June 23, 2018

RE: Mt Hope Project, Water Pollution Control Permit NEV2008106 renewal

Great Basin Resource Watch (GBRW) has reviewed the permit, fact sheet, and various background materials related to the Mt. Hope Project, and does not support this permit renewal. GBRW anticipates significant toxic drainage at this site with an insufficient plan to arrest the problem, which will result in violations of Nevada Law.

Figure 1: Snapshot from WPCP (2012) application Figure II-9 showing proposed monitoring

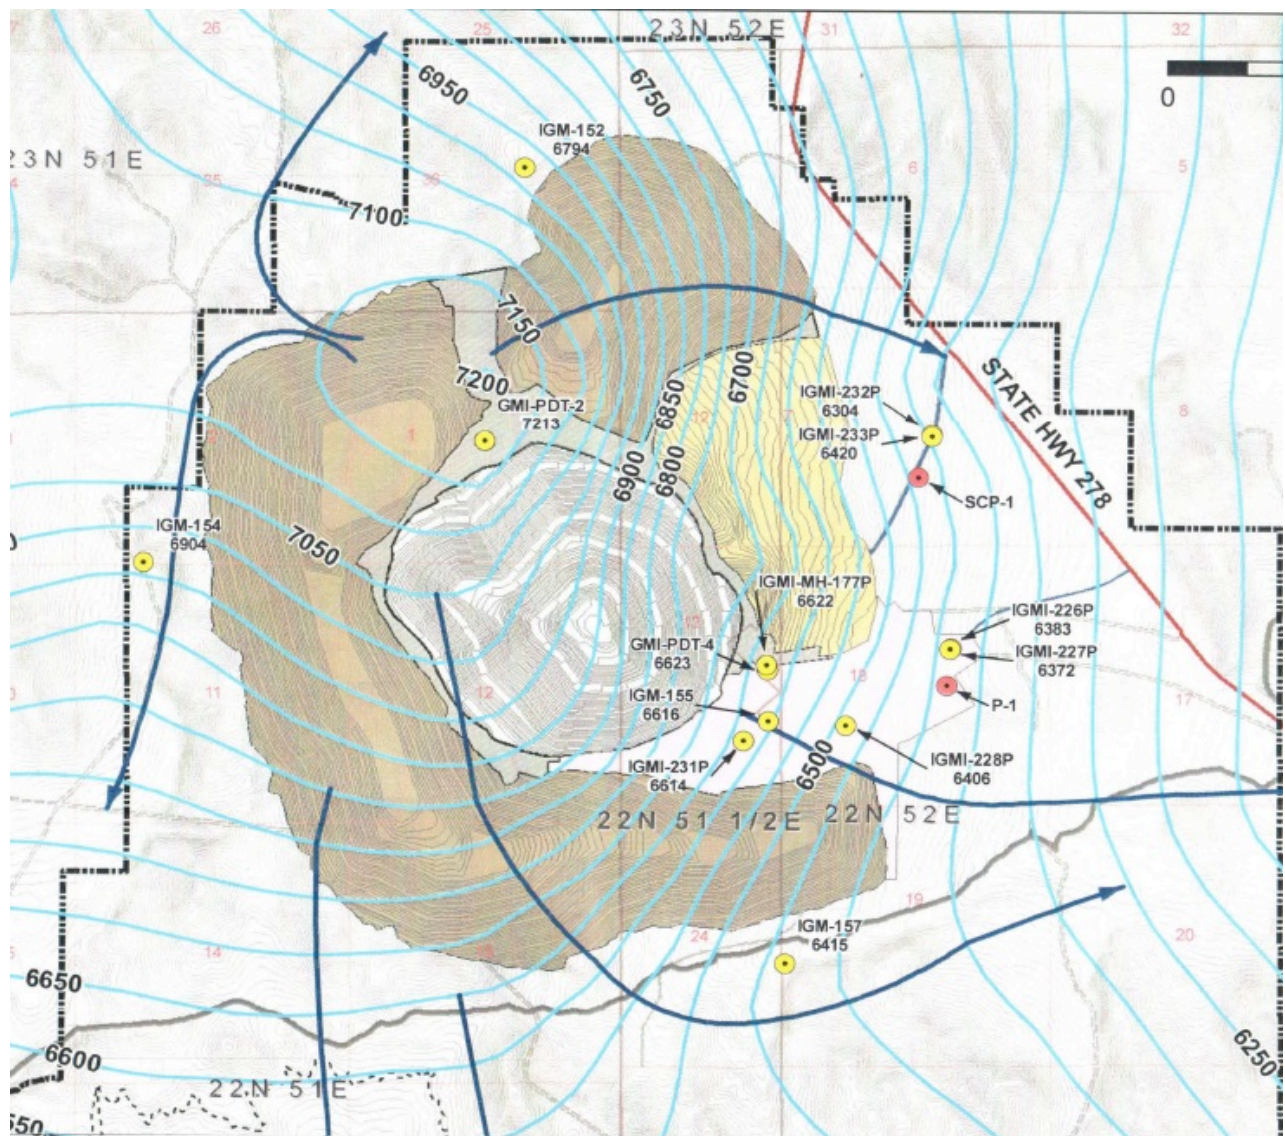
The draft permit specifies the monitoring wells associated with different mine components (section I.D (10).) The Non-PAG WRDF encircles the pit to the west and south (Figure 1). The draft permit states that well GMI-PDT-2 is upgradient of the facility; Figure 1 shows that that this well is existing and that a flow arrow through the well would be toward the pit, not under the waste rock dump. Well IGM-154 is considered downgradient but lies west of the dump and the flow path through it both up- and downgradient would not go under the dump. Well IGM-157 is on the southeast corner of the dump at a point where a flowpath would extend under the dump. At best, well IGM-157 is the only one that, based on its location, is properly located to monitor flowpaths that could actually transport contaminants from the waste rock dump. Even if IGM-154 is on a proper flowpath (it is not), it is separated from IGM-157 by several miles; a huge contaminant plume could advect south and southeast from the waste rock between the monitoring wells without being detected. It is essential that at least three additional monitoring wells that screen across the water table be constructed along the southern boundary of the Non-PAG waste rock dump west of IGM-157.

LGO stockpile lies east of the pit. The draft permit specifies that monitoring well SCP-1, IGMI-232P, and IGMI-233P are downgradient monitoring wells. Figure 1 confirms that all three lie on flow paths which flow beneath the stockpile. However, the IGMI wells appear to be at the same point. Well logs show these are both deep wells screened far below the water table. IGMI 232-P is screened from 1018 to 998 feet below ground surface (bgs) in shale with static water level at 763 ft bgs while IGMI 233-P is screened from 568 to 548 feet bgs in tuft with static water level at 85 ft bgs. Neither report indicates where water was first encountered nor are there geophysical logs in the application with which to determine saturated levels. These wells are apparently monitoring fracture zones in the respective lithologies. There is no discussion of how the monitoring depth was chosen, but it is reasonable based on the fractures and the dip of the formations that monitoring at this depth is warranted. However, a couple of shallower wells that screen any water levels in the alluvium are necessary. Well SCP-1 should be constructed to span the water table if there is a phreatic aquifer in the area; the permit should specify these construction details.

Wells IGM-152, -226P, and -227P are all called downgradient monitoring wells for the PAG WRDF. The latter two are east of the southernmost end of the LGO stockpile and not downgradient of the PAG WRDF. IGM-152 is northwest of the PAG WRDF (Figure 1) and the groundwater contours

show that a flowpath intersecting this well would not be underneath the PAG WRDF. The wells as shown on Figure 1 and specified in the draft permit will not monitor the PAG WRDF. Basically, this permit will allow the PAG waste rock to not be monitored. NDEP should specify at least three new monitoring wells east of the PAG WRDF with depth to screen chosen based on the presence of a water table aquifer and the presence of fracture flow zones at depth, as in the wells east of the LGO stockpile.

1. At least three additional monitoring wells that screen across the water table should be constructed along the southern boundary of the non-PAG waste rock dump west of IGM-157.
2. LGO (low grade ore) Stockpile Monitoring: a couple of shallower wells that screen any water levels in the alluvium are necessary. Well SCP-1 should be constructed to span the water table if there is a phreatic aquifer in the area; the permit should specify these construction details.
3. At least three new monitoring wells east of the PAG waste rock dump with depth to screen chosen based on the presence of a water table aquifer and the presence of fracture flow zones at depth, as in the wells east of the LGO stockpile.

Figure 2: Snapshot from WPCP application (2012) Figure II-9 showing proposed monitoring wells and groundwater contours near the tailings impoundment. The yellow wells have already been constructed.

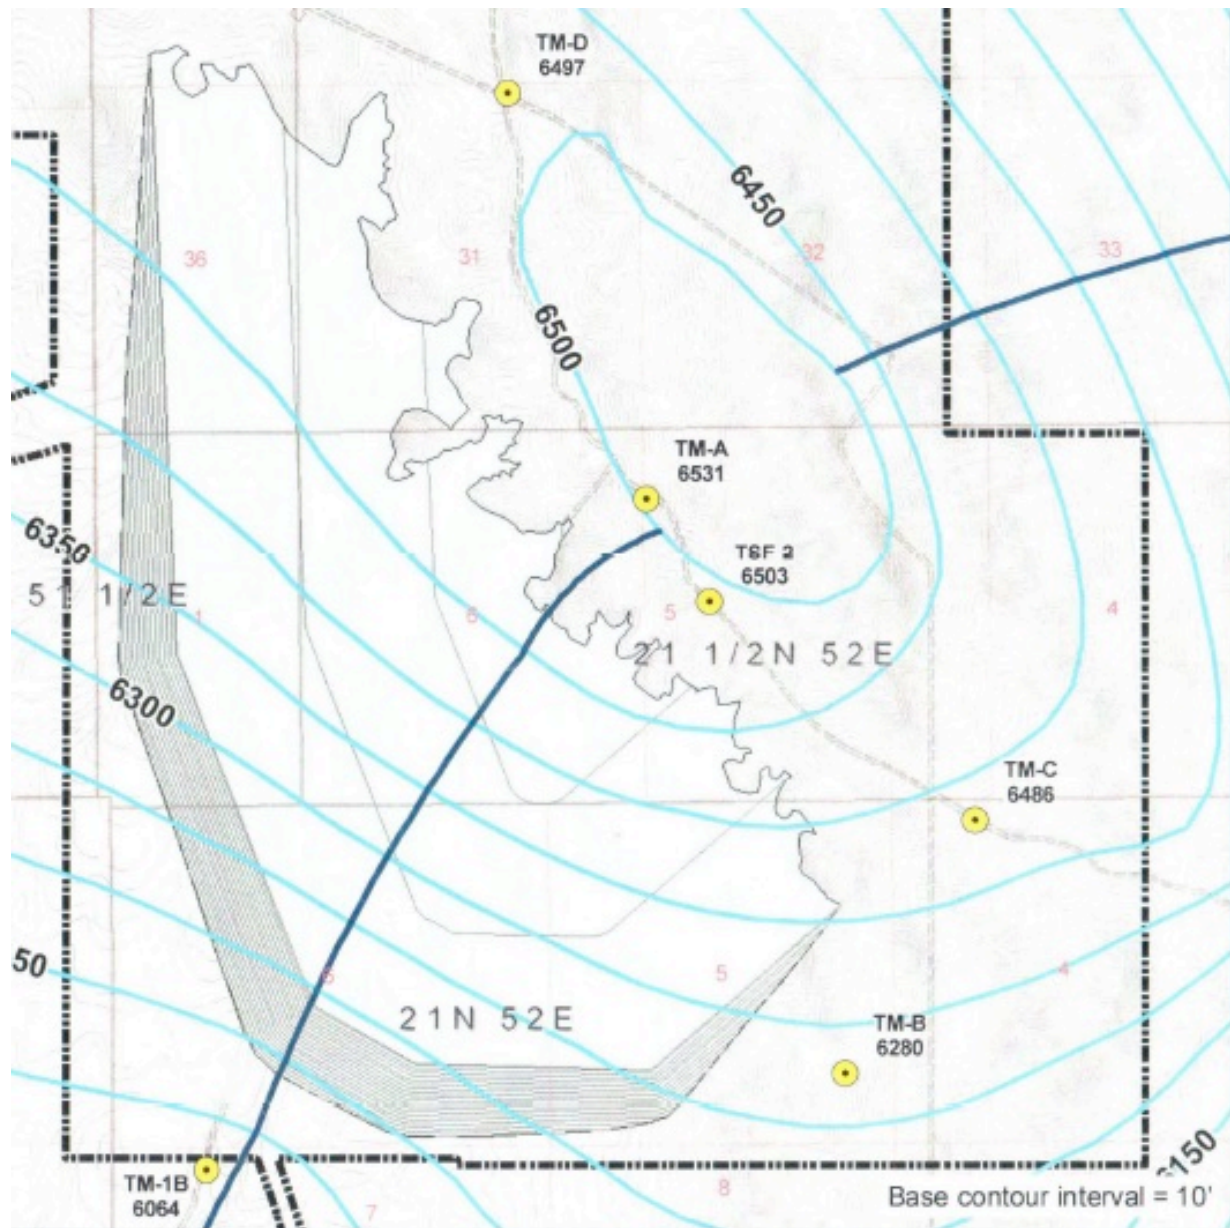
The tailings impoundment would be south of the pit. It lies southwest of the groundwater divide, therefore the groundwater flow will be to the southwest under the facility (Figure 2). The original draft permit indicates that four upgradient and two downgradient wells will be used to monitor this site.

Figure 2 shows clearly that well TM-B is cross-gradient from the facility, although the original draft permit refers to it as one of the two downgradient wells. A flowpath through this well would pass just east of the easternmost portion of the facility, therefore this well is not useful for monitoring contaminants from the tailings impoundment. Wells TM-D, TM-A, and TSF-2 appear to be adequate upgradient monitoring wells, but well TM-C is also too far east; a flowpath through TM-C would miss the tailings impoundment by a quarter mile.

The original draft permit therefore has just three adequate upgradient wells and one downgradient well. Because of the size of the impoundment and the potential contamination from leaky tailings, it is obvious there should be at least four additional monitoring wells downgradient from the tailings facility. Two should lie between TM-1B and TM-B and two should lie on a line between TM-1B and the number 6300 on the contour space about 1/3rd mile north from TM-1B.

Figure 3: Diversion channel and ponds near the proposed pit, from FEIS figure 2.1.5

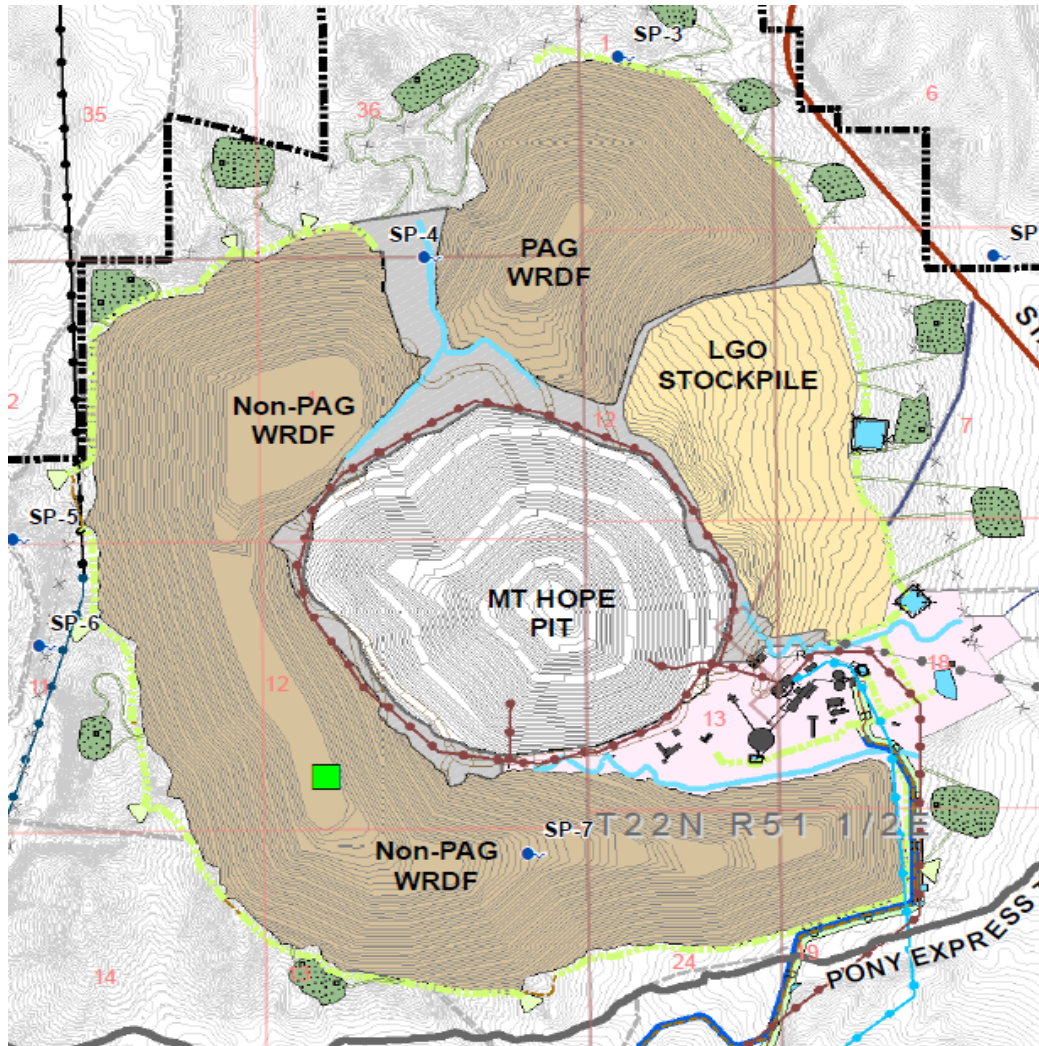
GBRW is aware that the Bureau of Land Management disagrees with our suggestion of the potential for flow-through conditions; however, appropriate monitoring of groundwater surrounding the open pit should be part of the monitoring plan to assure that groundwater is not being degraded.

Figure 4. Graph extracted from the Mt. Hope FEIS.

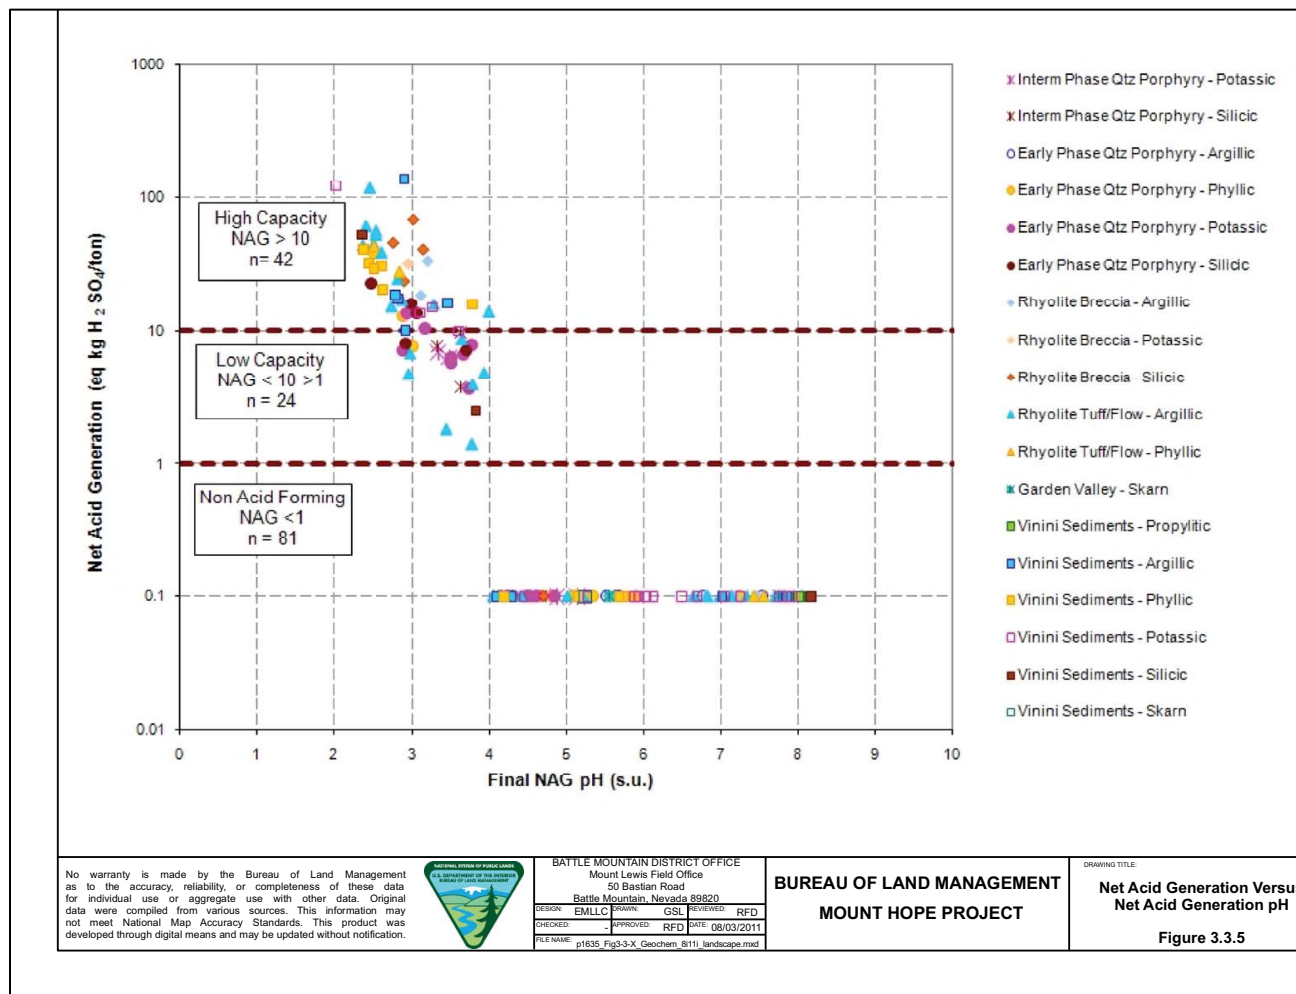
The data available¹⁸, despite being sparse, do indicate a significant potential for acid generation, but with very little neutralizing capacity. For example, Figure 3.3.5 (FEIS, Figure 4 below), Net Acid Generation Versus Net Acid Generation pH, shows that 29% of the samples to be net acid generating and another 16% in the questionable category, so the conservative approach would be to assume that 45% or almost half could be acid forming to various extents.
